# Product change notification

**Products affected:**  **ORAGENE-Dx**  **ORAGENE-DISCOVER**  **ORAGENE-DNA**  **ORAGENE-ONE**

**Catalog numbers/REFs:** OGD-600, OGD-610, OGD-675, OGR-600, OGR-675, OG-600, OG-610, OG-675, ON-600

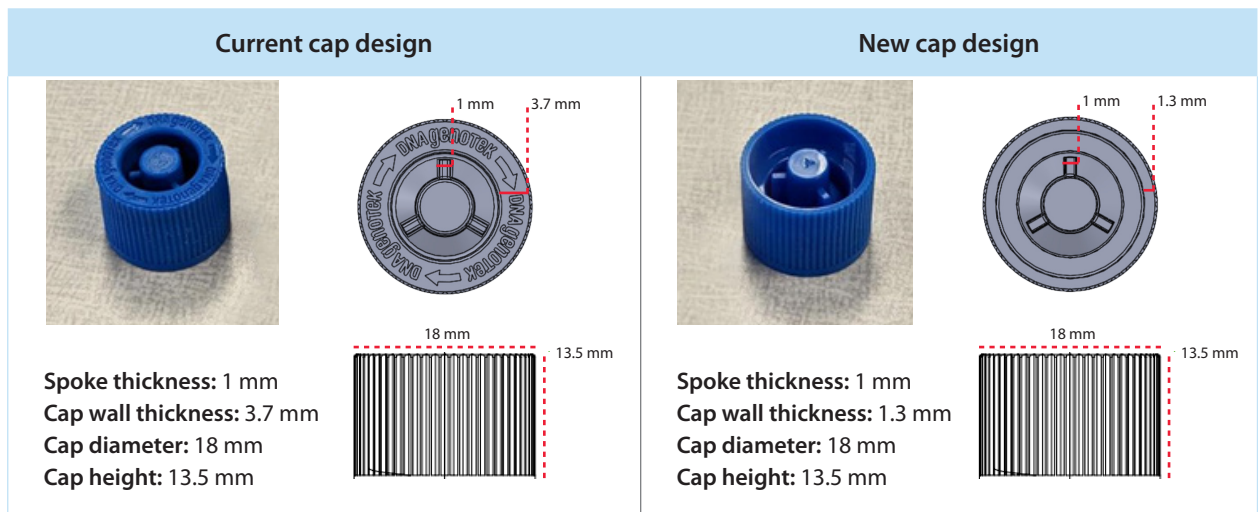
A design change has been made to Oragene® 600 series cap. The cap wall thickness has been reduced from 3.7 mm wide to 1.3 mm. All other cap specifications remain unchanged.

The Oragene 600 series cap design has been implemented to support improved moulding capacity and product inventory.

- No action is required for laboratories manually decapping collected Oragene 600 series samples.
- The cap design change is not expected to impact compatibility with automated decapping instruments; however, laboratories using automated decapping instruments should review the cap specifications to confirm there is no impact. To request caps to verify compatibility, contact your account manager.
